SERVICE BULLETIN

* Supersedes Service Bulletin SB900-102, dated 09 May 2006. Revised to correct part number of affected component and add requirement to insert RFM Temporary Revision TR06-002 in appropriate flight manual.

INCREASED GROSS WEIGHT CAPABILITY TO 6500 LBS WITH V_{NE} CARD AND LH MIDDLE AFT TRUSS ASSEMBLY REPLACEMENT

Service Bulletin SB900-102R1, Increased Gross Weight Capability To 6500 lbs With V_{NE} Card and LH Middle Aft Truss Assembly Replacement

Figure 1. VNE Card

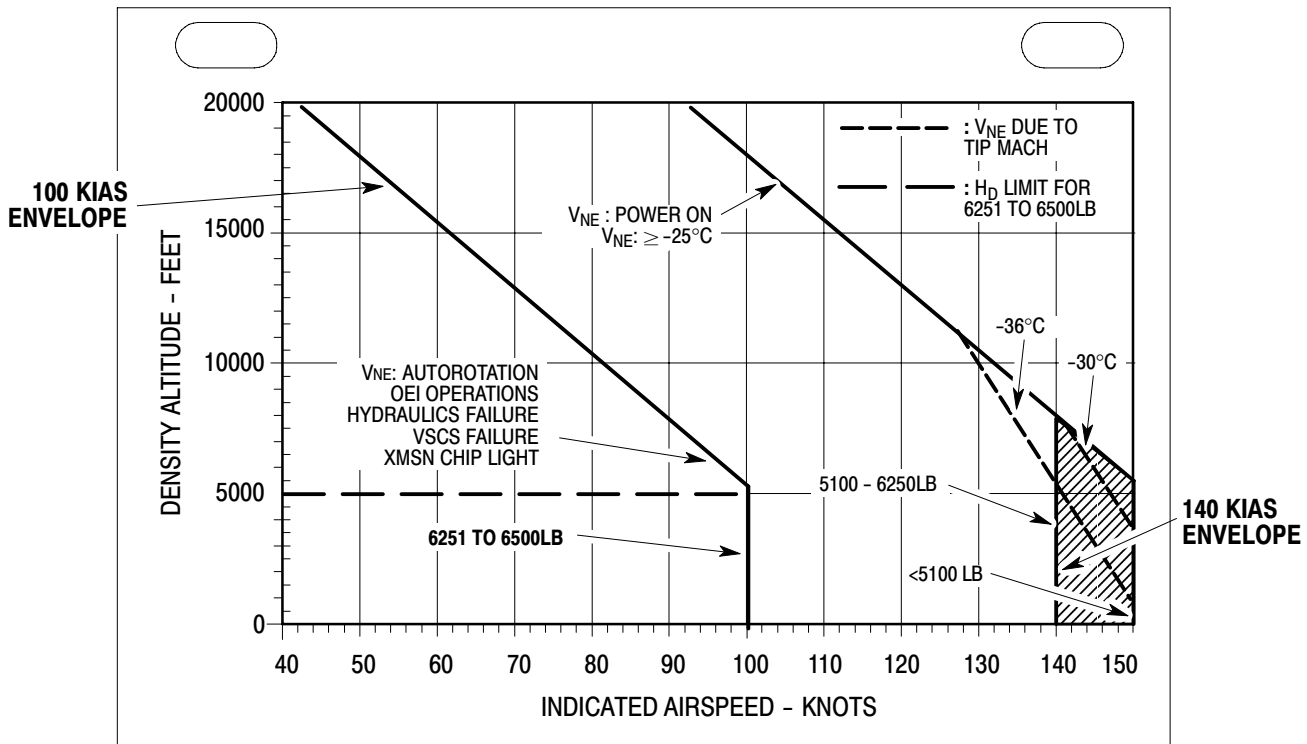
- (1). Incorporate appropriate Temporary Revision TR06-001 and TR06-002 into the RFM.
- (2). Verify that P/N MHS5949A10 VNE Card is installed.

(Ref. Figure 1)

- (a). If necessary, install P/N MHS5949A10 VNE card.
- (3). Record compliance to Part 2 of this Bulletin in the Rotorcraft Logbook.
- (4). Complete Part 2 of the Bulletin Compliance and Recording Form (attached) and FAX to MDHI Field Service Dept.
